**APPLICATION NO. A/NE-TK/837 FOR PERMISSION
UNDER SECTION 16 OF THE TOWN PLANNING ORDINANCE**

Section 16 Application No. A/NE-TK/837

Annex 1 - Response to Comments Table

Section 16 Application for Temporary Public Vehicle Park (Private Cars Only) with Ancillary Electric Vehicle Charging Facilities and Ancillary Solar Panels and Associated Filling of Land for a Period of 3 Years at Lot No. 241 in D.D. 23 at Ting Kok, Tai Po, New Territories

Annex 5 : Sightline Analysis

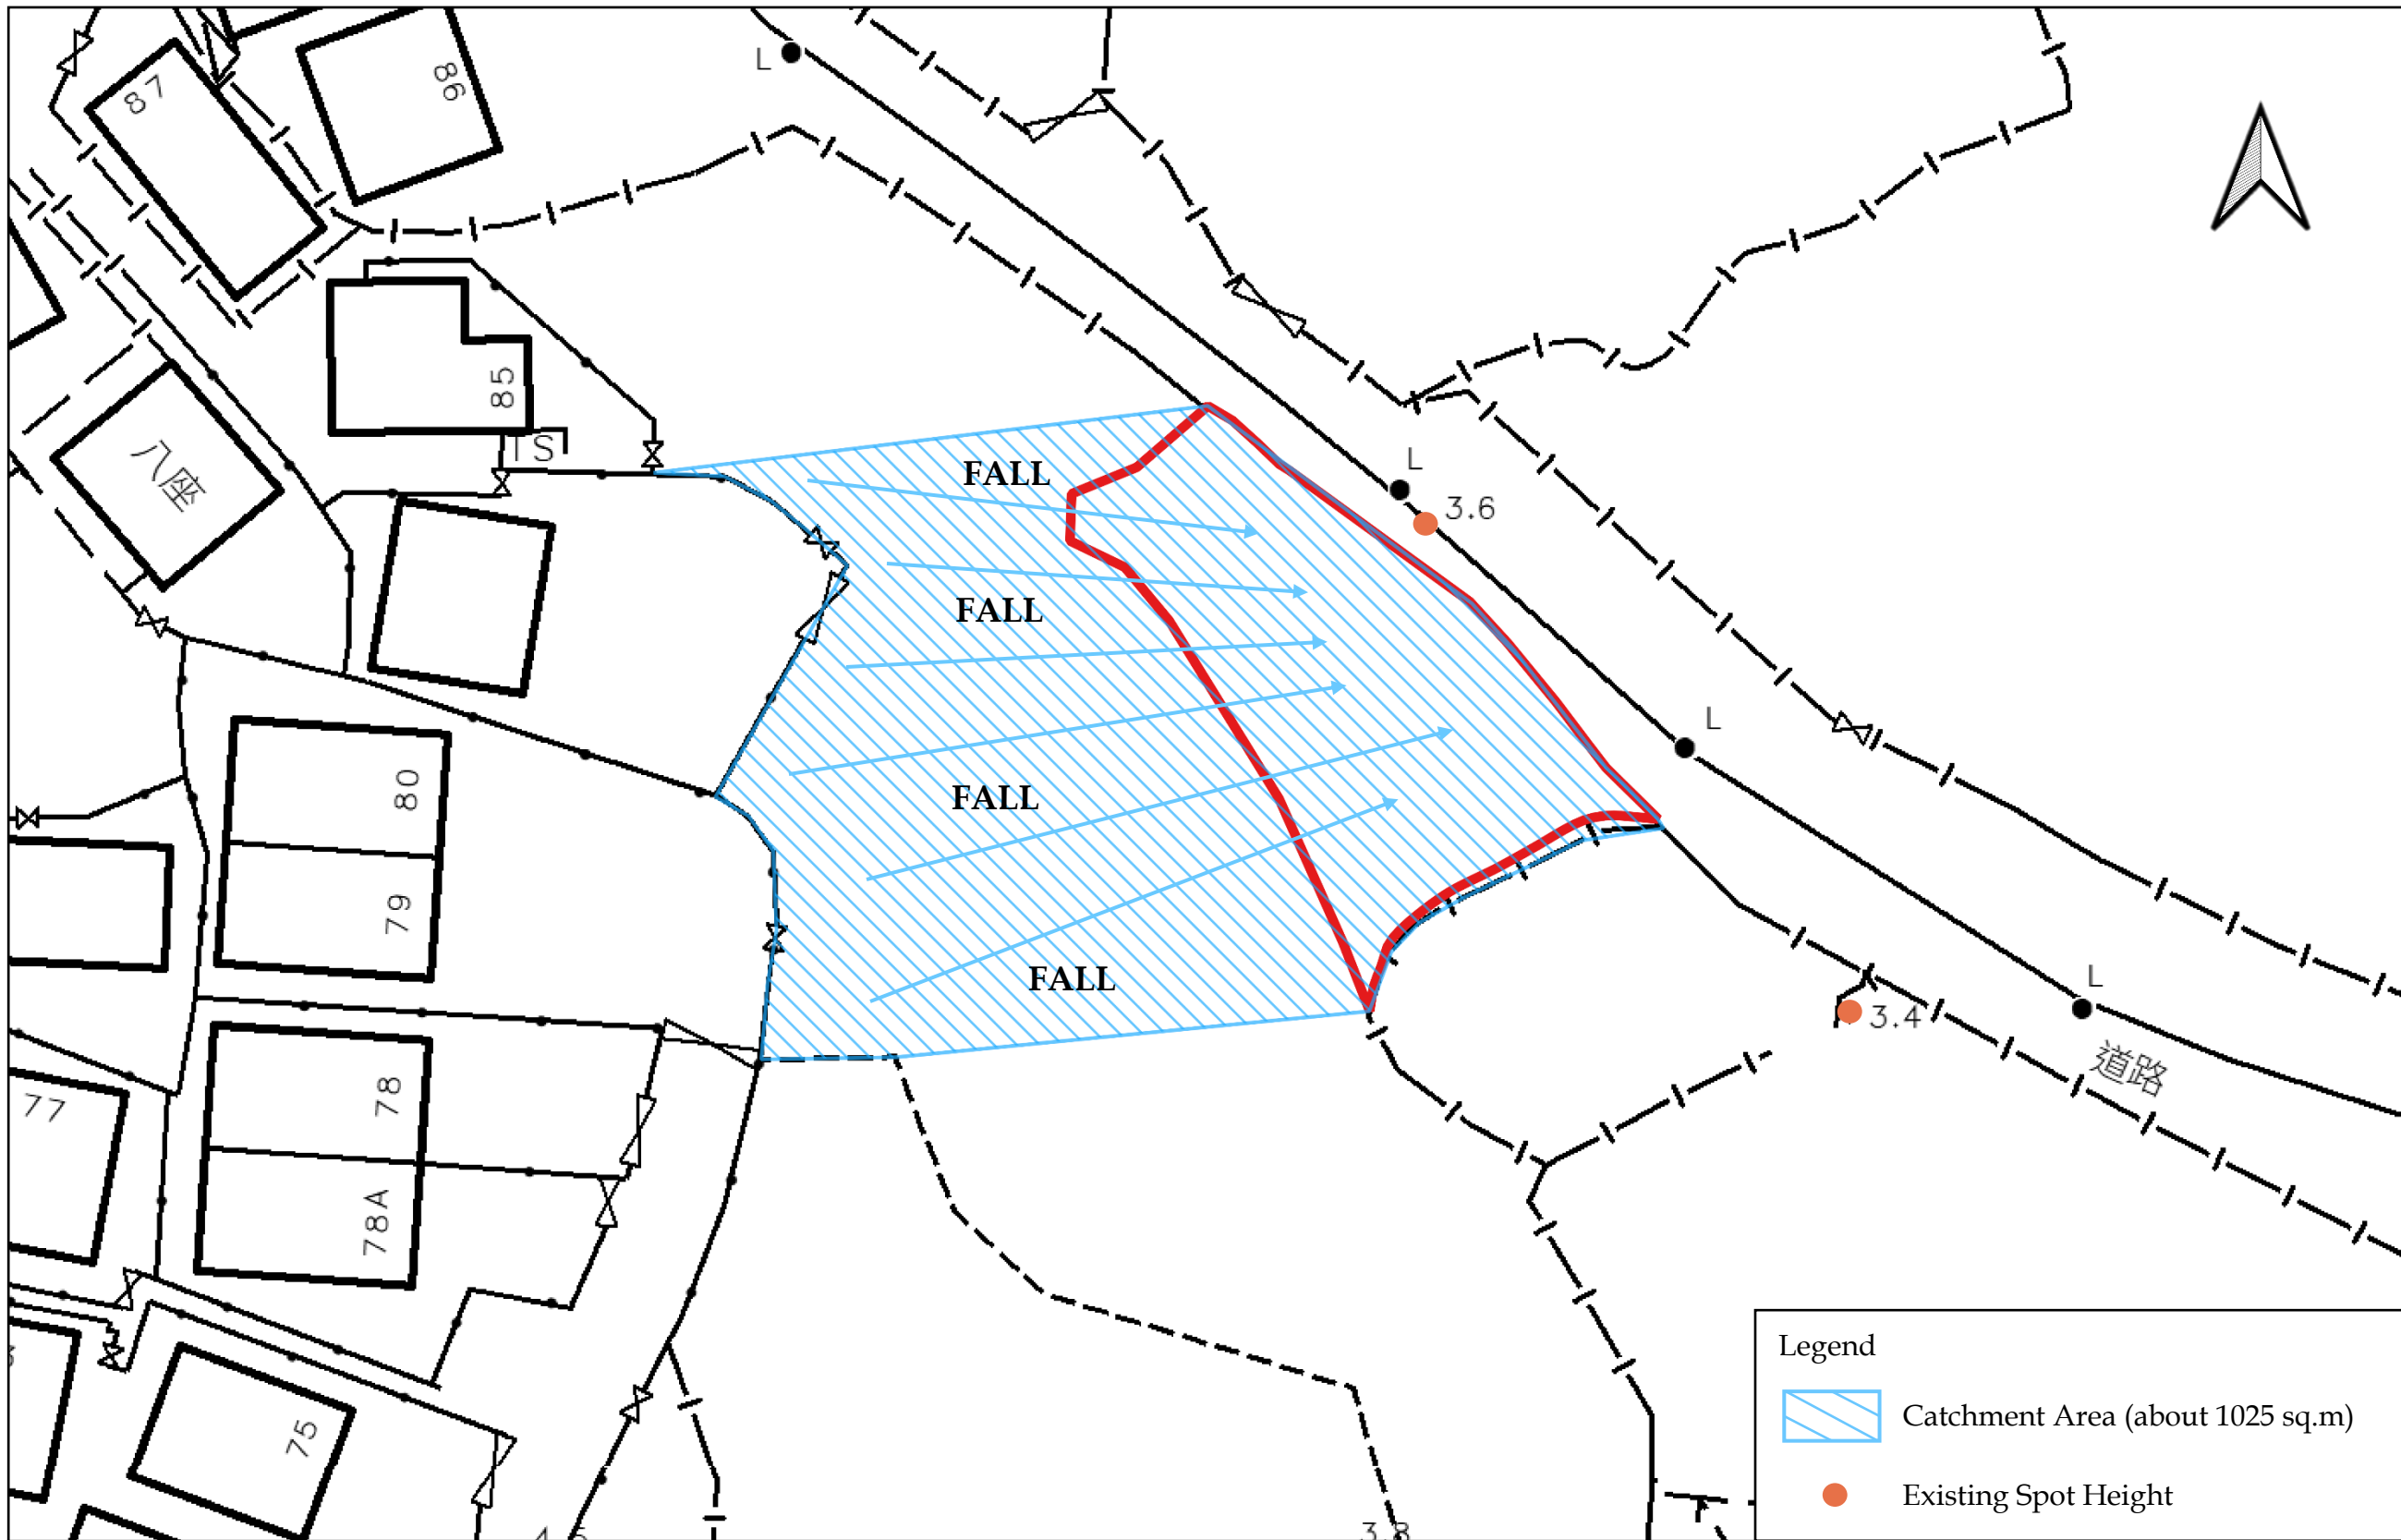
conducted to identify and address any emerging safety concerns during the operation of the proposed vehicle park.
q	The sightline assessment shall be conducted at a point 2m from the edge of access road and the sightline shall cover the entire section of access road.	Noted, the sightline analysis in Annex 5 have been revised according to the departmental comment.
r	All plans shall be in scale.	Noted.

Annex 6 : Drainage Proposal

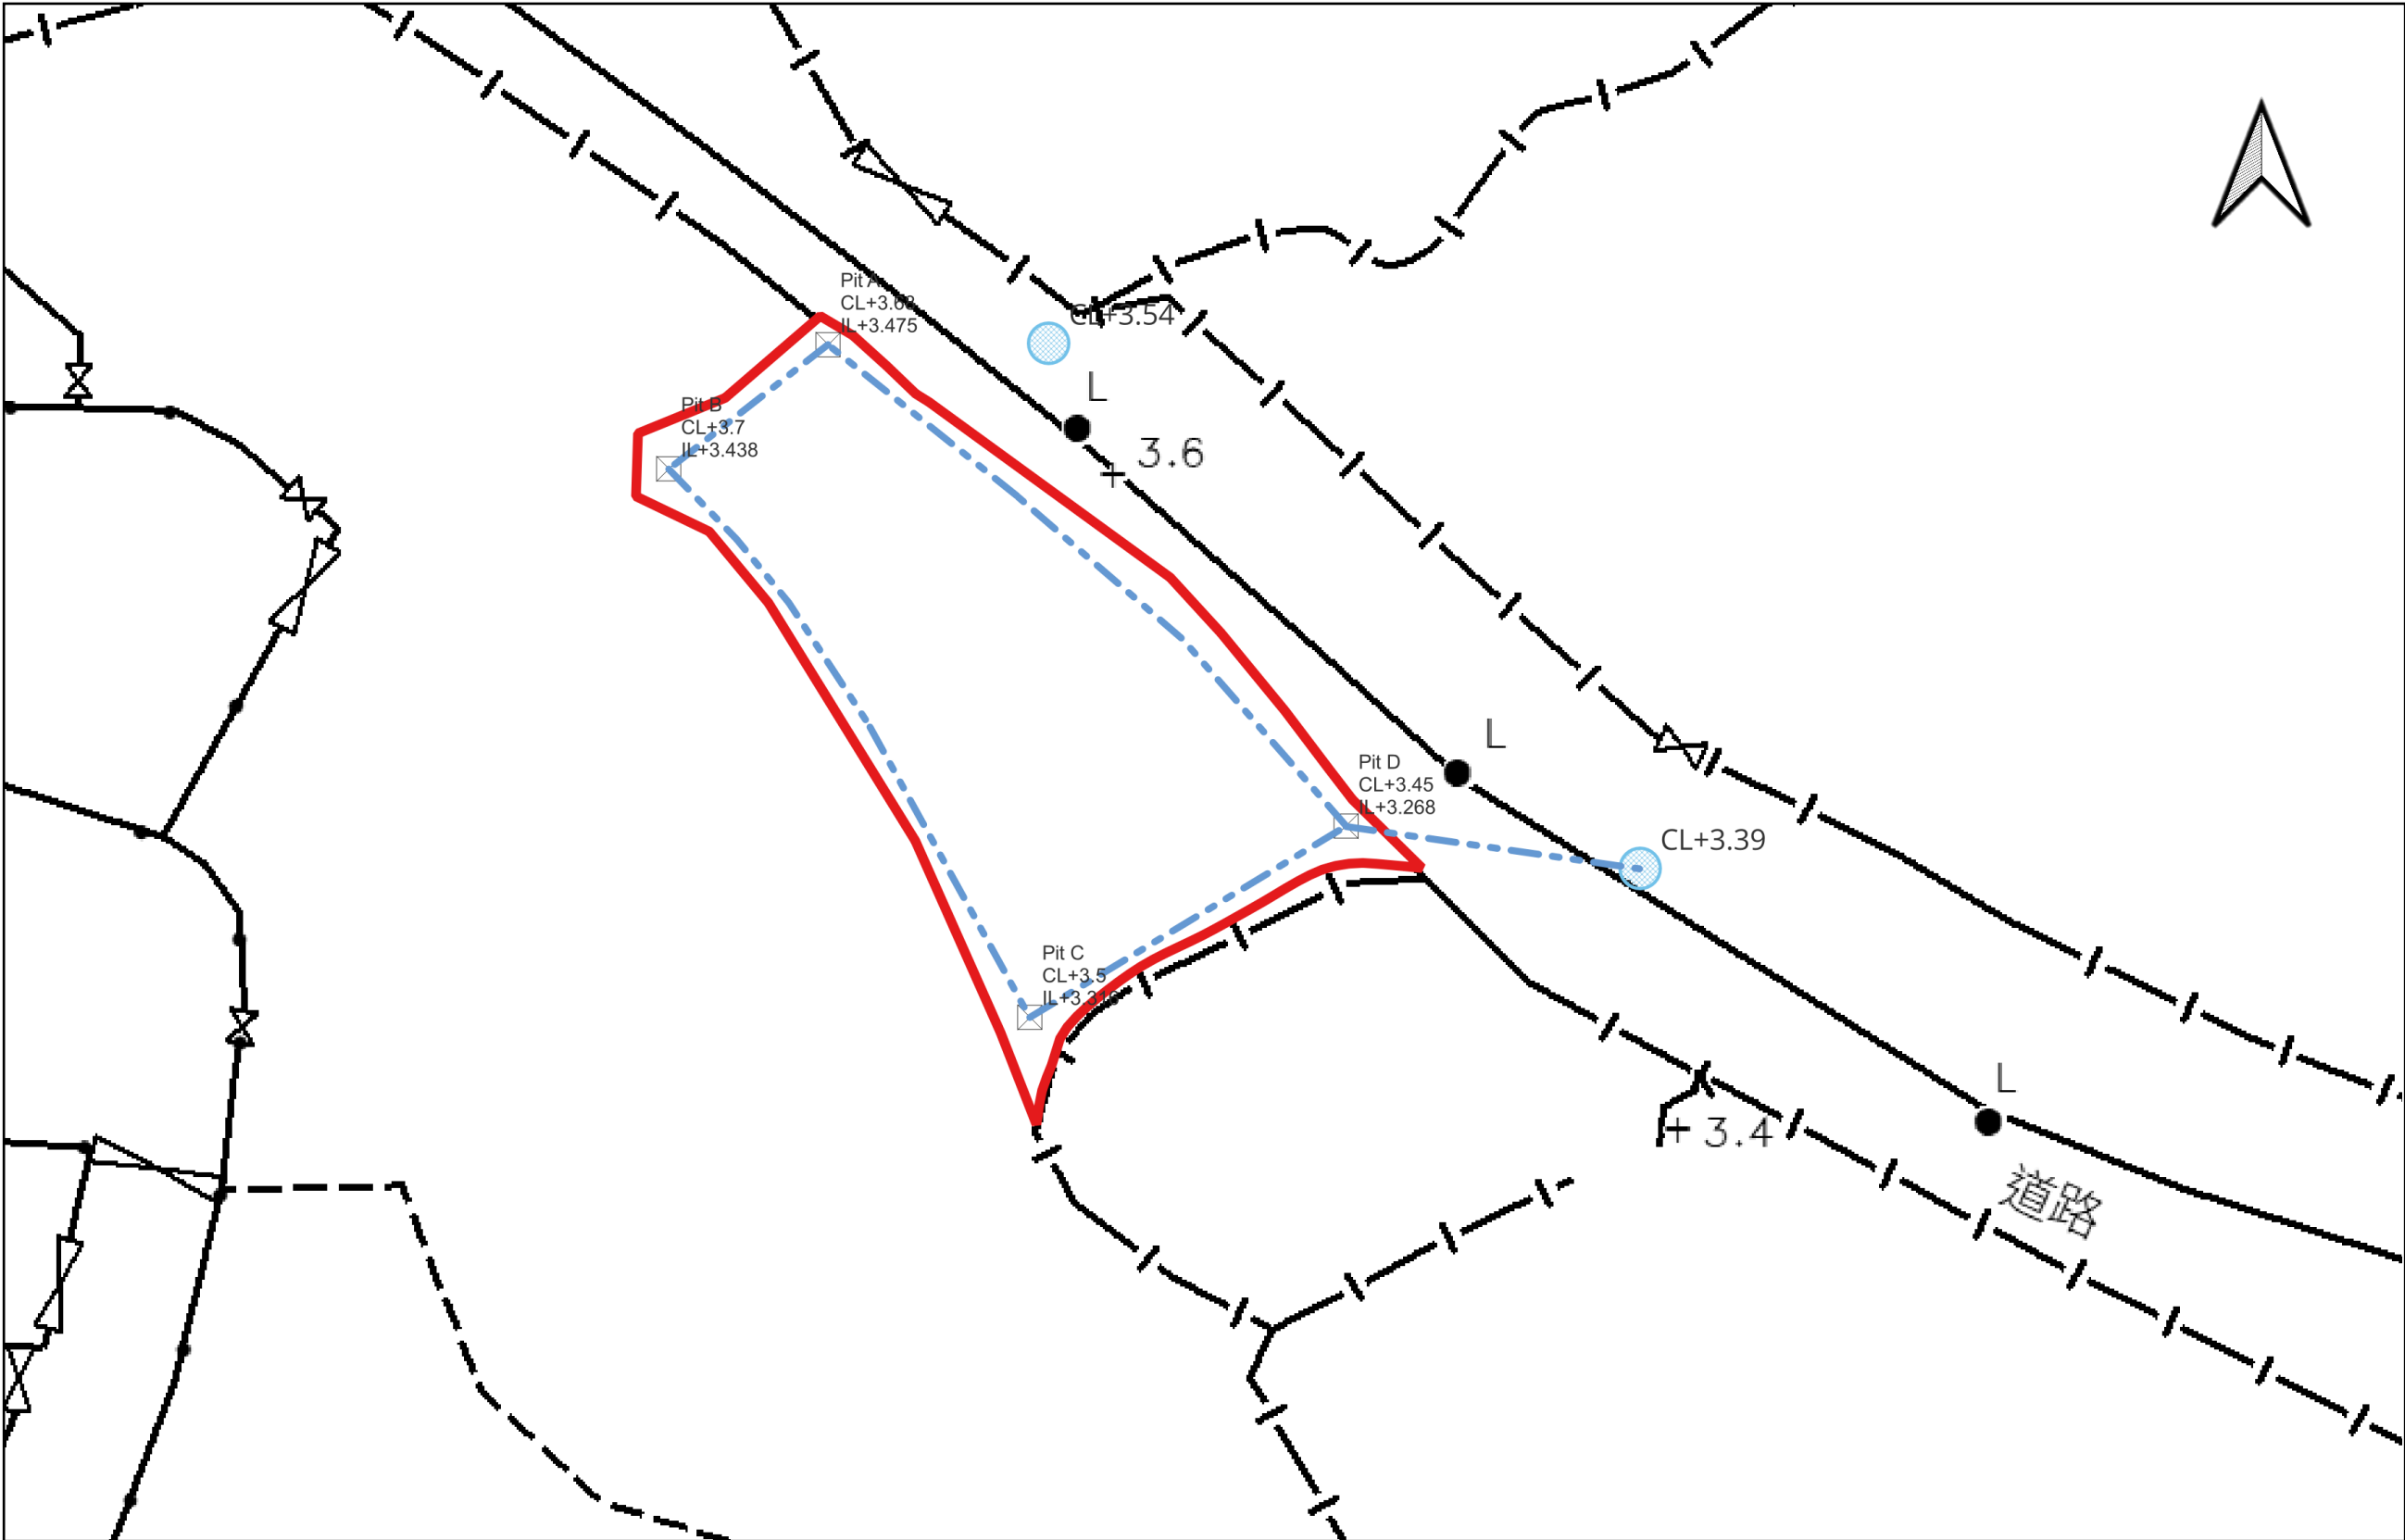
c	Surface channels should be provided along the perimeter of the site to collect all the runoff generated from the site or passing through the site, and discharge the runoff collected to a proper discharge point.	Noted, a preliminary drainage plan is provided in Annex 6 .
d	The catchment area appears underestimated.	Noted, a preliminary drainage plan is provided in Annex 6 .
e	The rainfall intensity should be increased by 16% according to Table 28 of SDM Corrigendum No. 1/2022.	Noted.
f	Reduction in flow area should be taken in account in accordance with Section 9.3 of SDM.	Noted.
g	The drainage flow path from the drainage facilities within the Site to the public drainage system/streamcourse/sea/any recognized drainage facilities shown in LandsD map should be provided in associated with supporting site photos.	Noted, the supporting site photos are provided in Annex 6 .
h	Furthermore, I would like to draw the applicant's attention to the following general comments/requirements:	Noted.
